Request for Architectural Review Board Agenda Item

| From: ALEXIS KISER, ASSISTANT TO CITY ADMINISTRATOR | | | | | |
|---|---|----------------------------|---------------------|---------|--------------------------|
| NEW CONSTRUCTION |)N - DOLLAR GE | NERAL - ST. JAN | 1ES AVE (HWY 176 |) | |

MEMORANDUM

RE: New Construction – Dollar General on St. James Ave (TMS# 223-13-04-002, -033)

AR-1

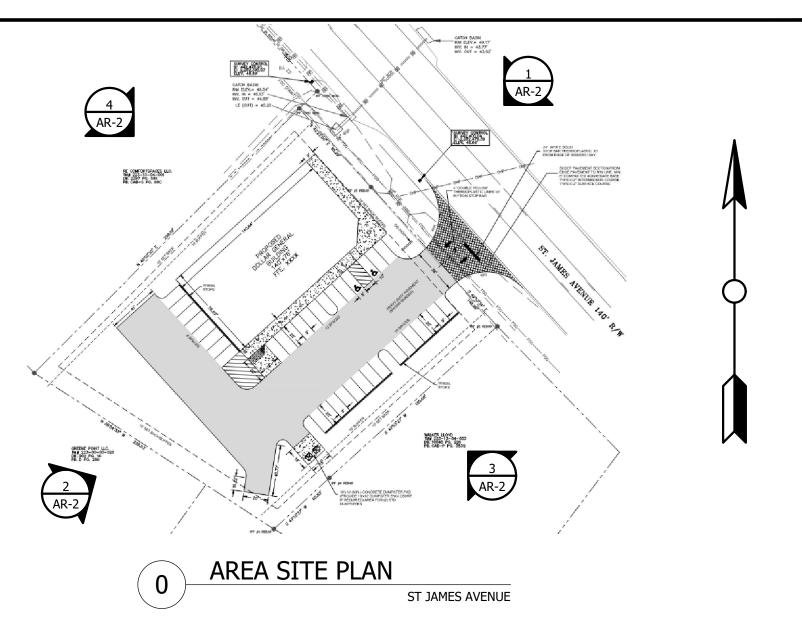
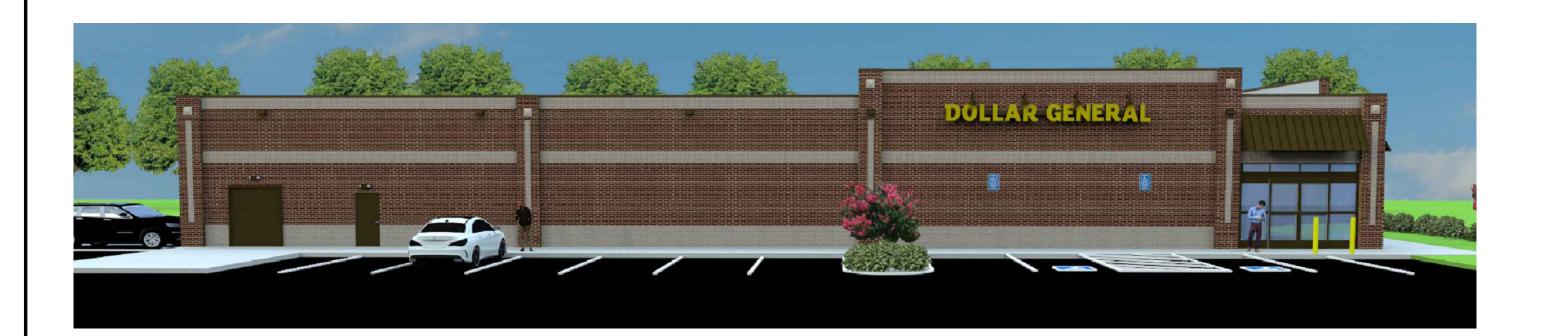
Staff would like to note that there are tree placements on the planting plan (Sheet L1) that are not shown in the renders of the proposed structure (sheets AR-1 and AR-2) and the render of the refuse enclosure (sheet A8). This is most likely as to not impede views of structures; however, it would be recommended to show this planting plan throughout all renders at lower opacity to keep continuity throughout application.

- Work with staff to make appropriate changes to the front elevation and elevation 3;
- Work with staff to bring design continuity to all sides of proposed structure with the addition of architectural elements recommended by the Board;
- Work with staff to determine the location of light poles in and around the parking areas and along St. James Avenue (HWY 176);
- Work with staff to rethink design choices to help create a structure that moves further away from the category of "franchise architecture"; and
- Instruct applicant to clarify the accurate site plan for the development.

AR-2

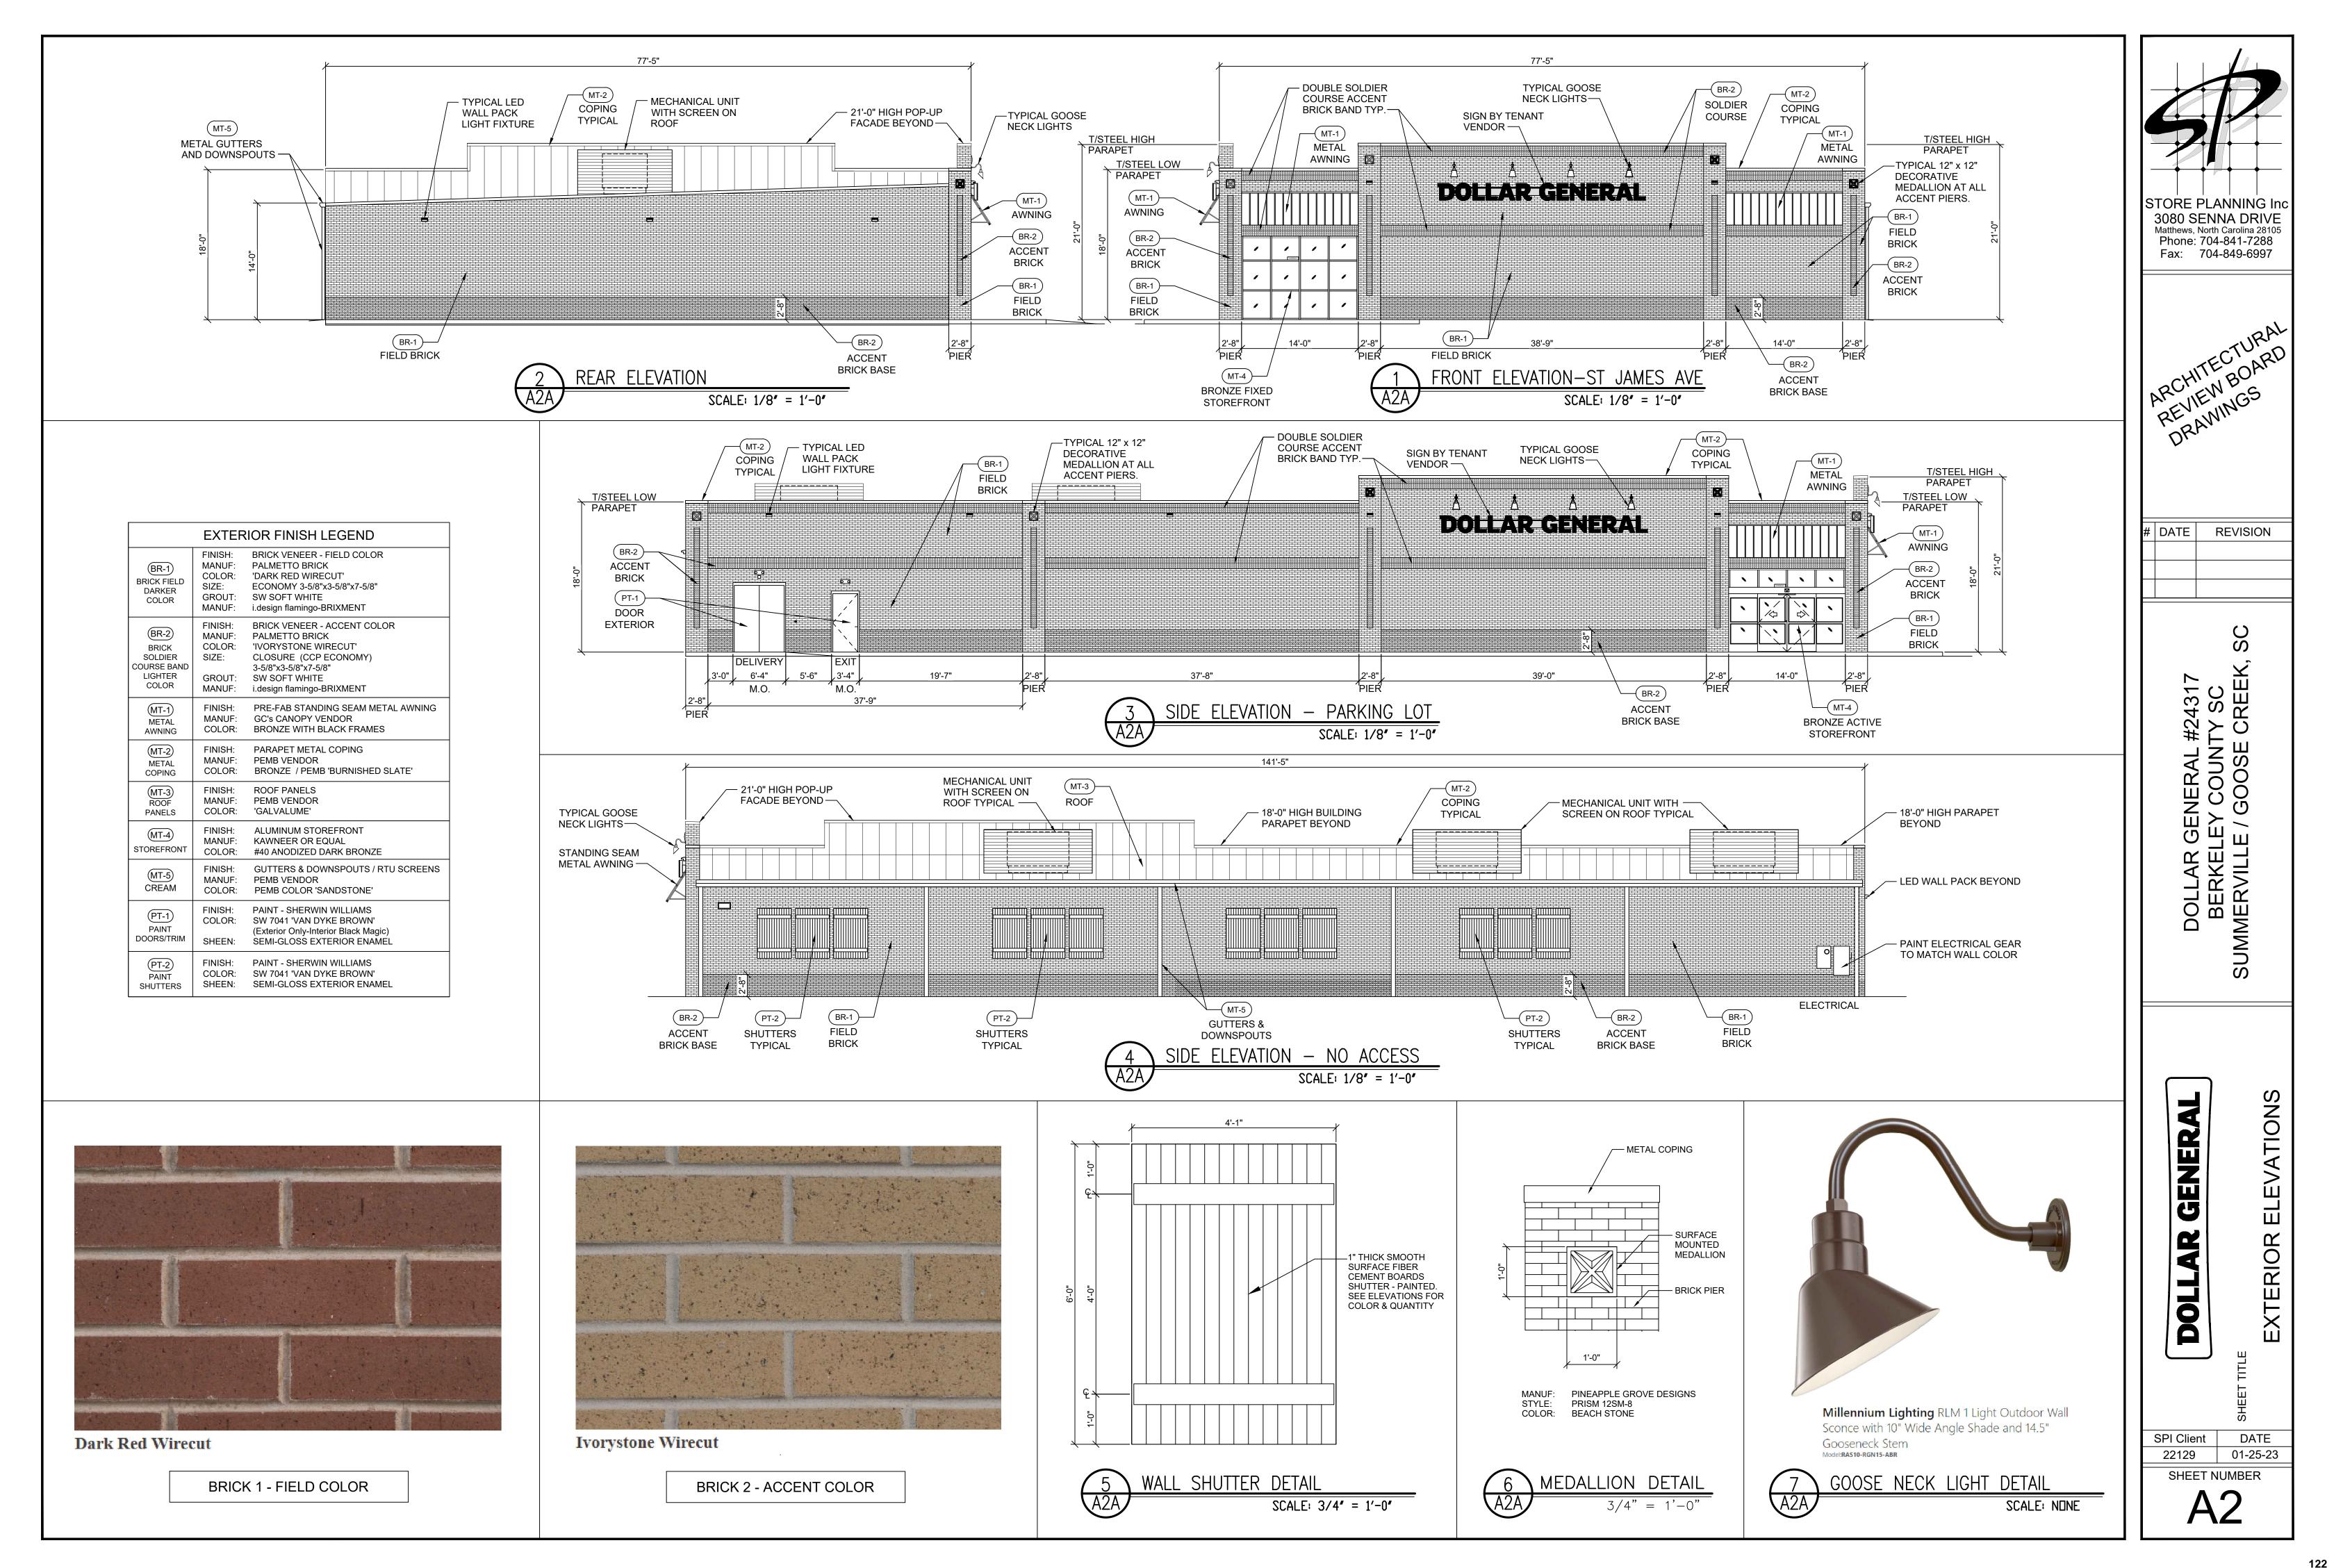
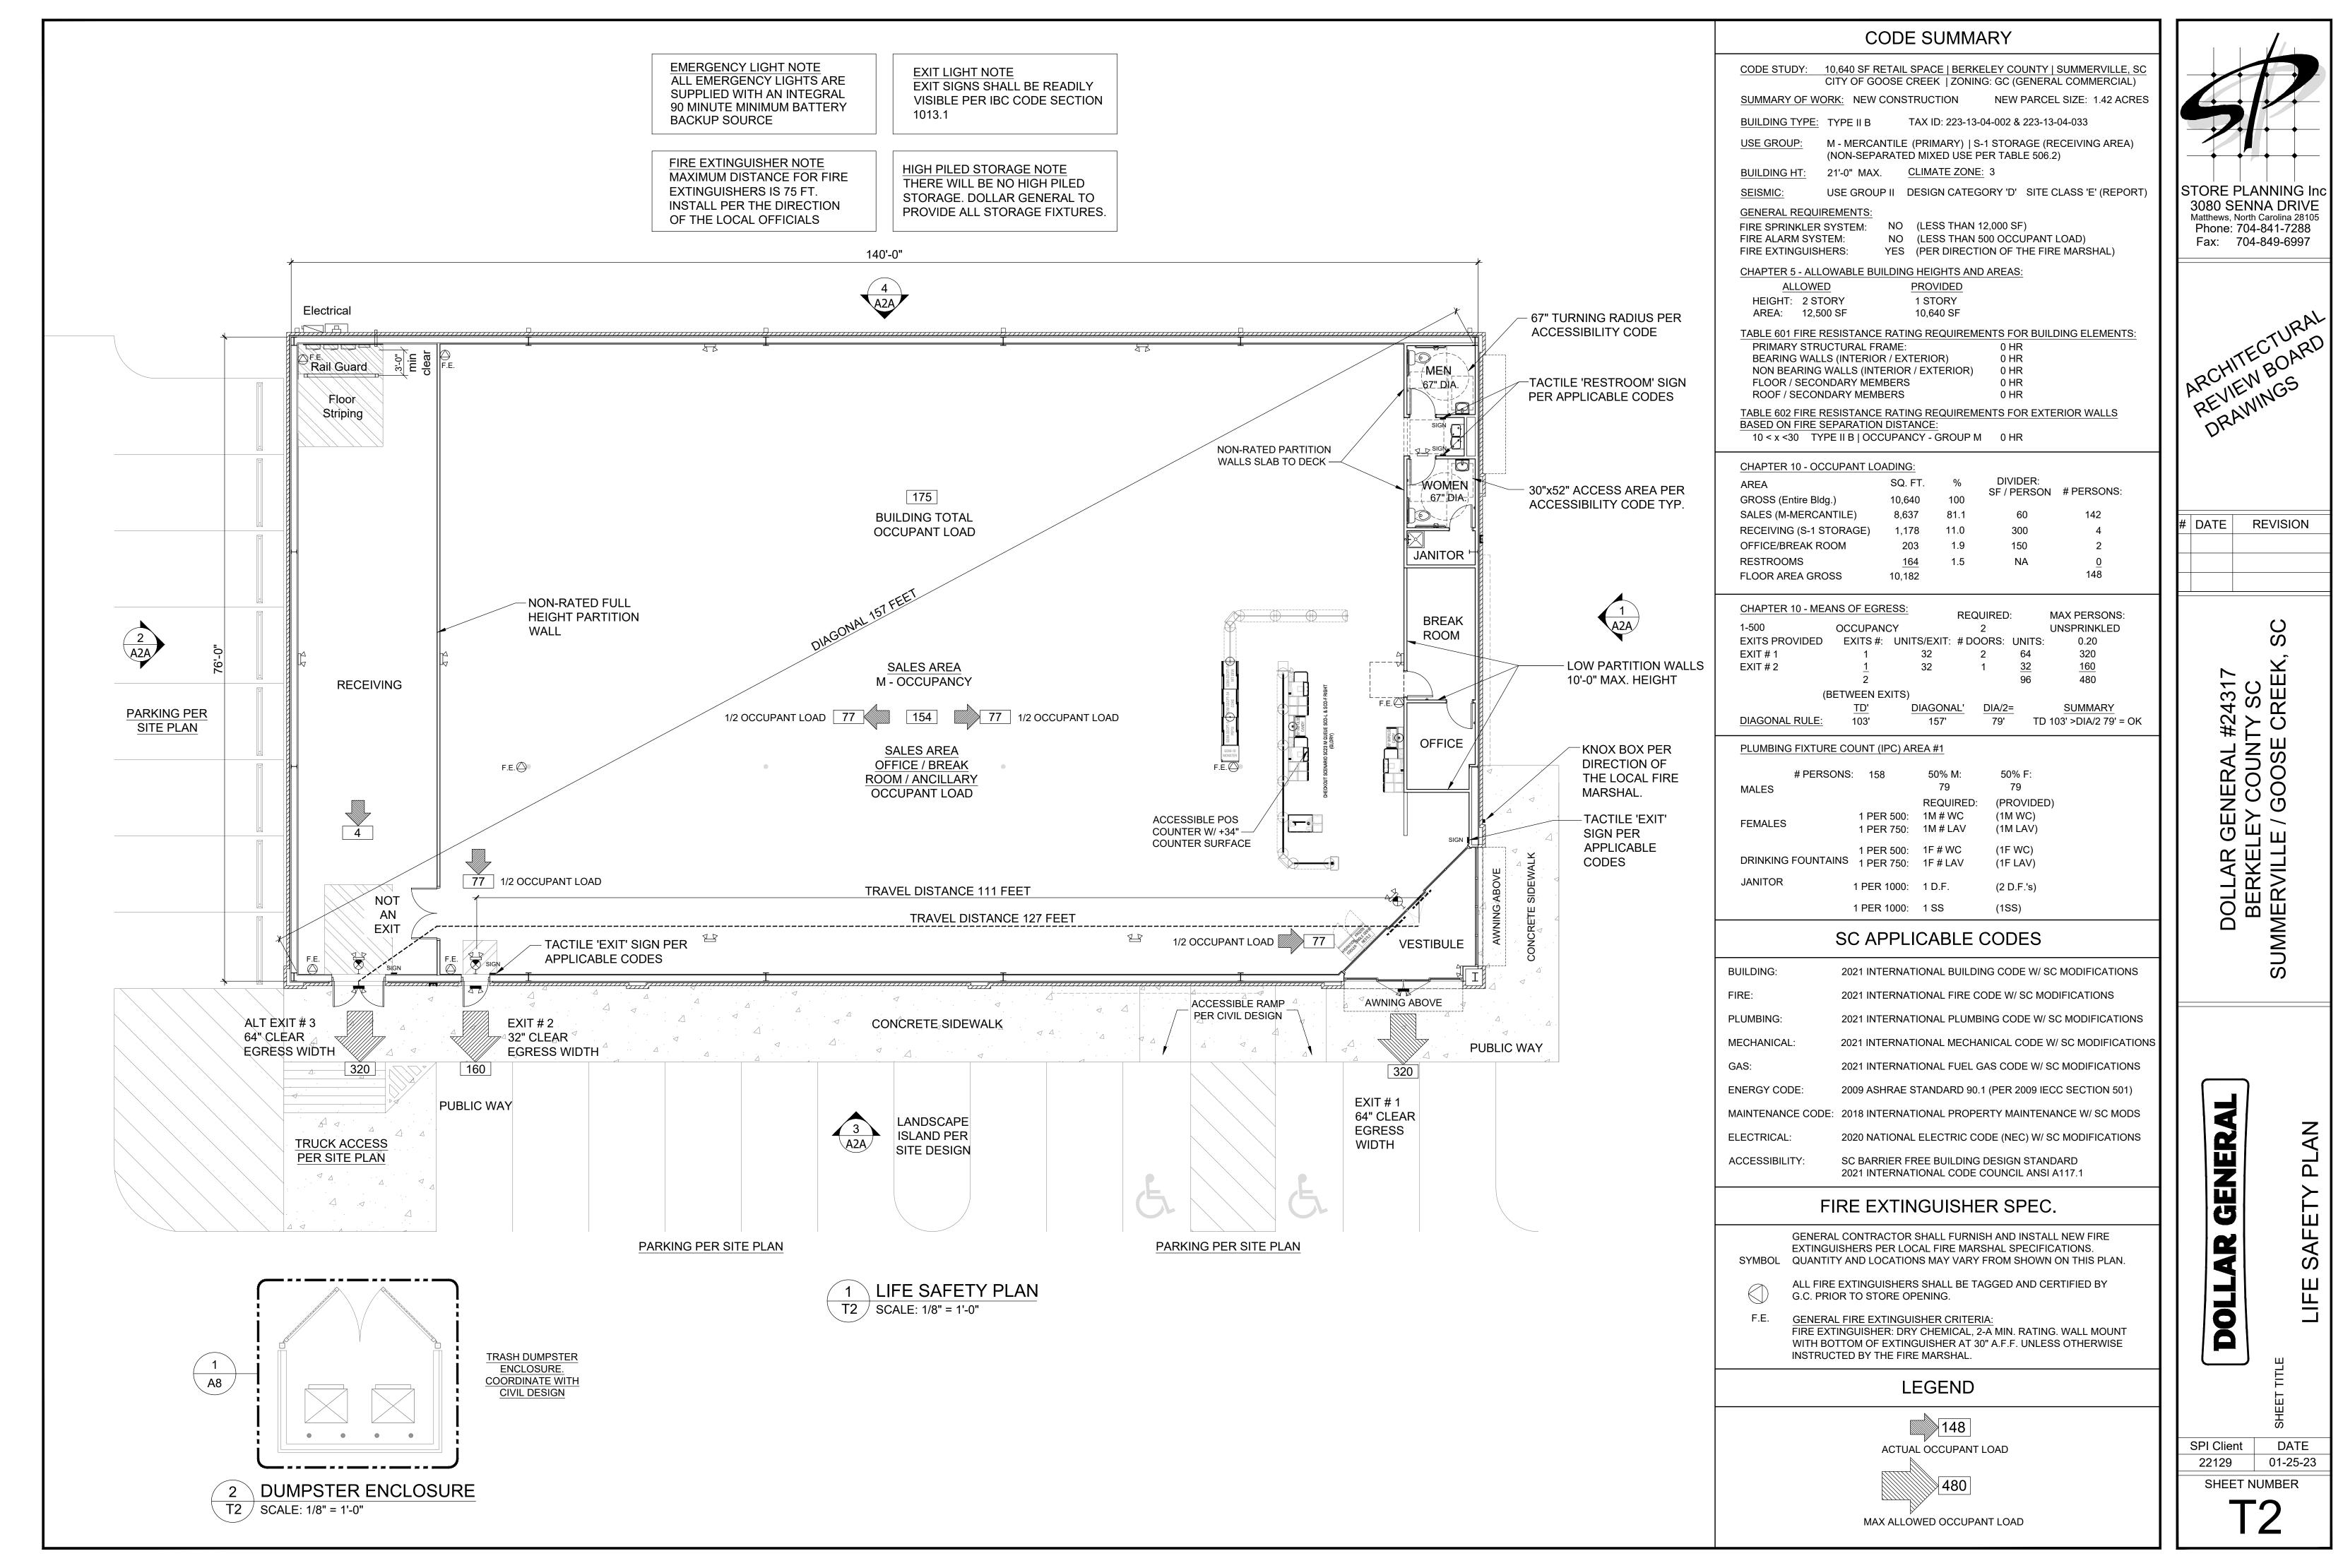
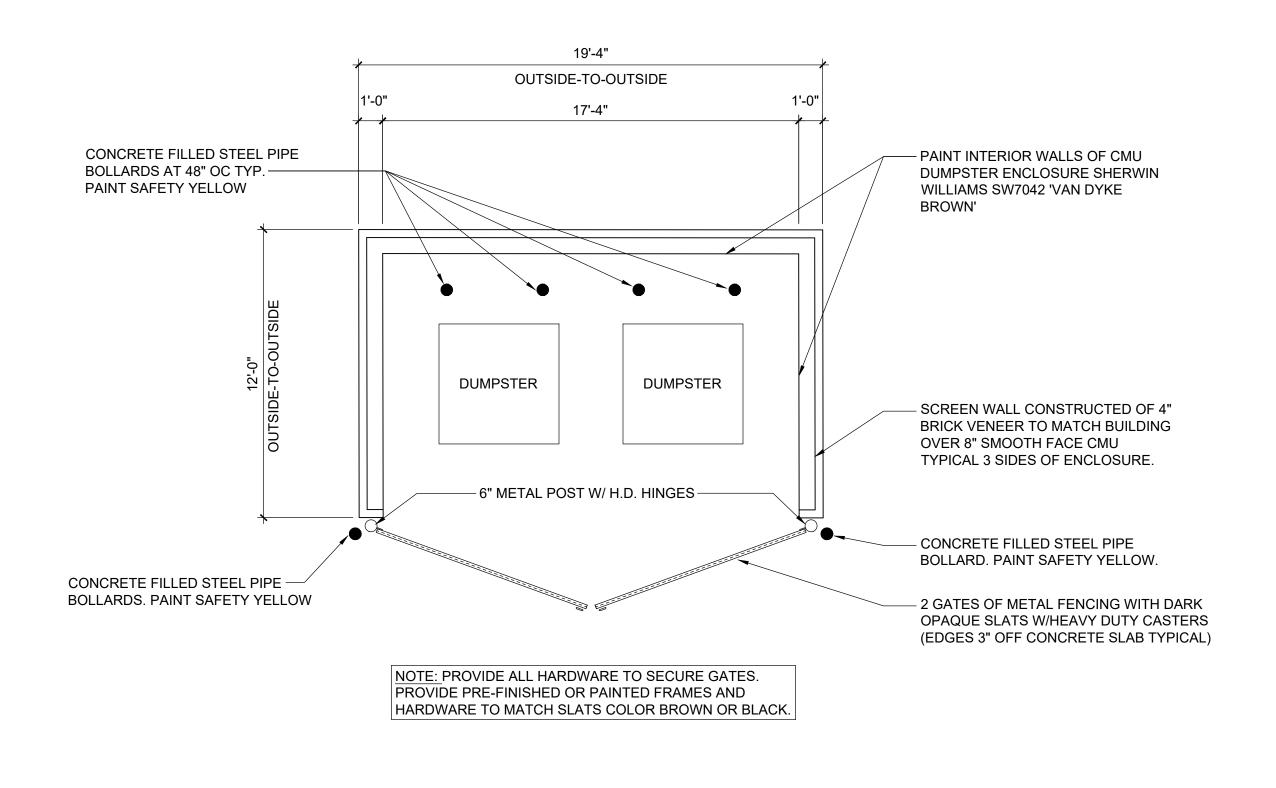
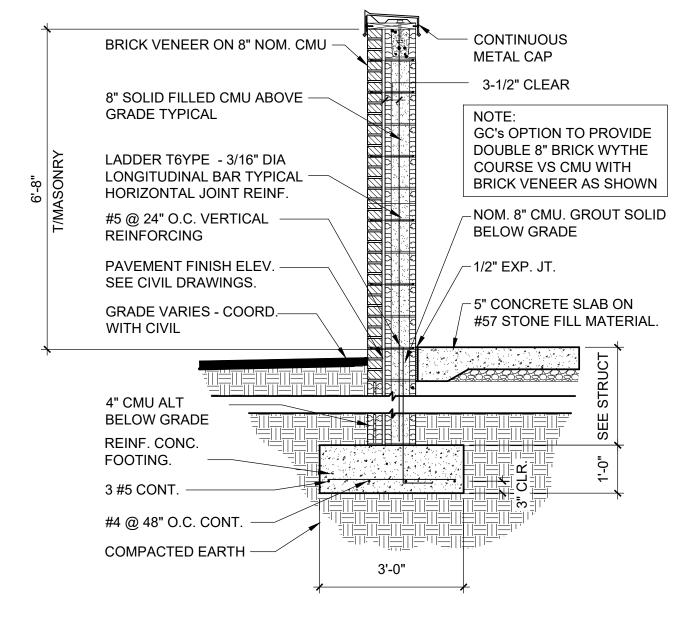
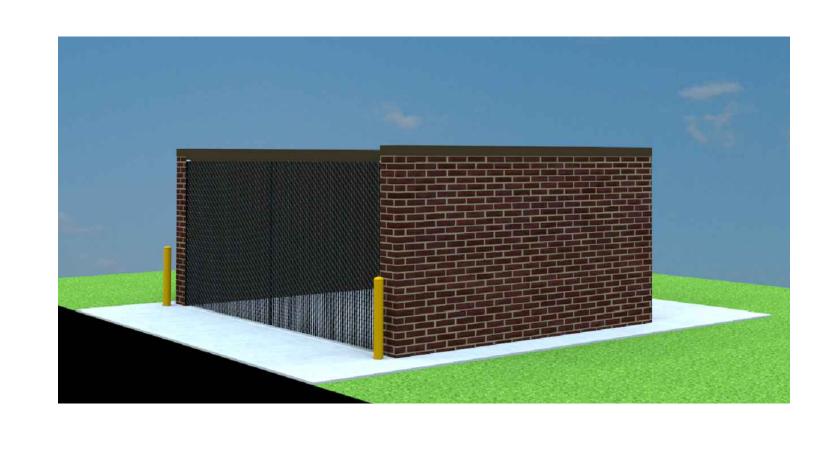
The site plan used on sheet AR-2 is not the same proposed site plan on sheet C2 (truck turn around adjacent to refuse collection site is different).

Incorporation of façade variations and bringing design continuity to the entire proposed structure will help bring architectural interest to the structure. It will also help alleviate some aspects that make this structure "Franchise architecture". Staff also recommends instructing applicant to clarify which site plan is accurate for this development (specific difference is truck space beside the refuse enclosure slopes in a different direction on sheet AR-2 vs. C2.)
